AMENDMENT OF SOLICITATION/MODIFICATION OF CONTRACT

Solicitation #: 140P1526Q0106

GLCA Concrete Pad

Questions and Government Responses listed below:

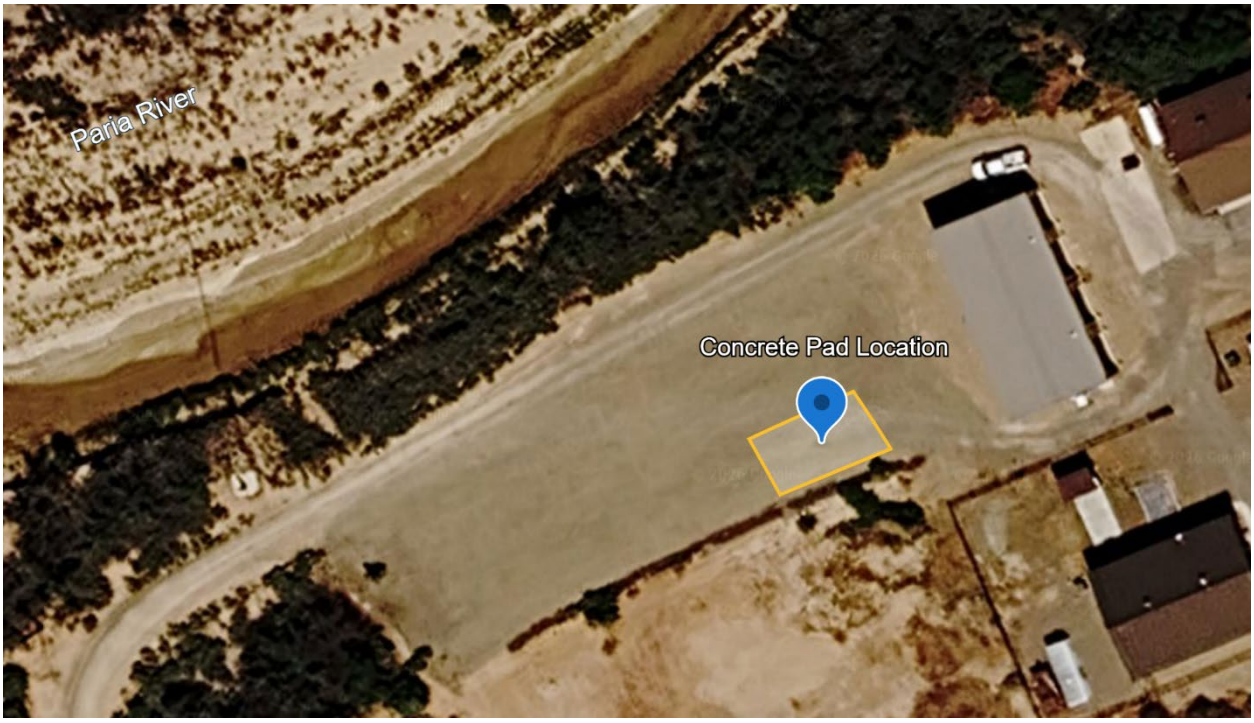
Question #	Question	Answer/Response
1	Is it possible to get photos of the site to determine whether it is flat?	The area is completely flat. See photos.
2	Is there a diagram of the boat garage or pre-engineered footing details for below the pad? Typically for a pad intended for a structure, footers are placed underneath the foundation posts/beams of the structure, and the weight of the structure affects the diameter or length/width of the footings.	The structure for the concrete pad will be a carport with a storage area. It is intended to shelter 4 boats. The carport will be 40' long x 30' wide.
3	Will there be control joints and are there required specifications for said control joints?	Control joints will be good but I don't have any required specifications.
4	Do you have a preferred type of aggregate base to be used for this structure?	Crushed stone would be preferred.
5	Where exactly will the work location be, and who will be there to mark the exact location on-site for the structure/pre-pour inspection?	The concrete pad will be located at Lees Ferry in Marble Canyon. It is about a minute drive from Page, AZ which is the nearest town
